File No. 25-00872

Reference: Preliminary/Final Minor Subdivision Plan – Review #1
435 Vanderslice Street
Tax Map Parcel Number: 15-9-60

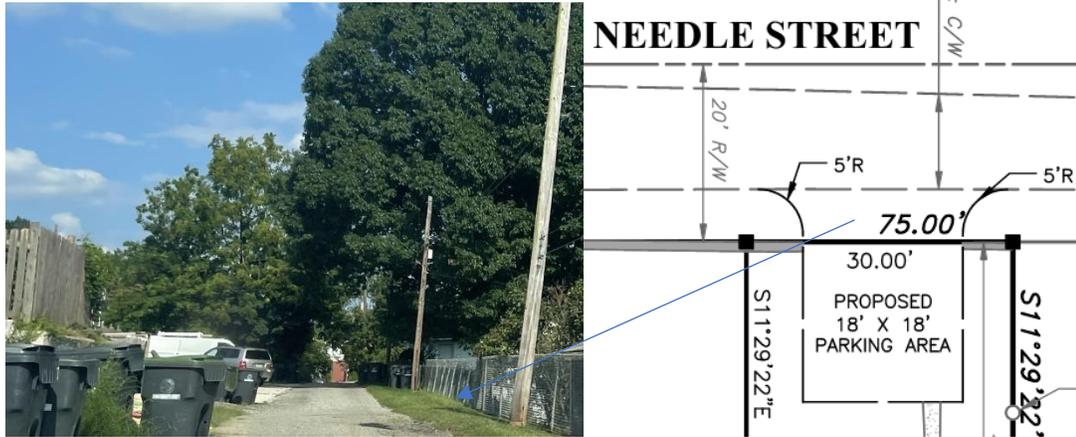
- a. As per ZO Section 27-405.2.C, "off-street parking shall be provided to meet the demand for the proposed land use."
 - i. The applicant proposes an 18 ft x 18 ft parking area for Lot 1 fronting on Needle Street providing two (2) parking spaces. The area for the proposed parking area is sloped. However, no grading plan has been submitted as part of this application. Additional information should be provided.
 - ii. There is no development proposed as part of this application. However, the plans should be revised to include a note indicating that parking will be provided on Lot 2 as required by the ordinance.
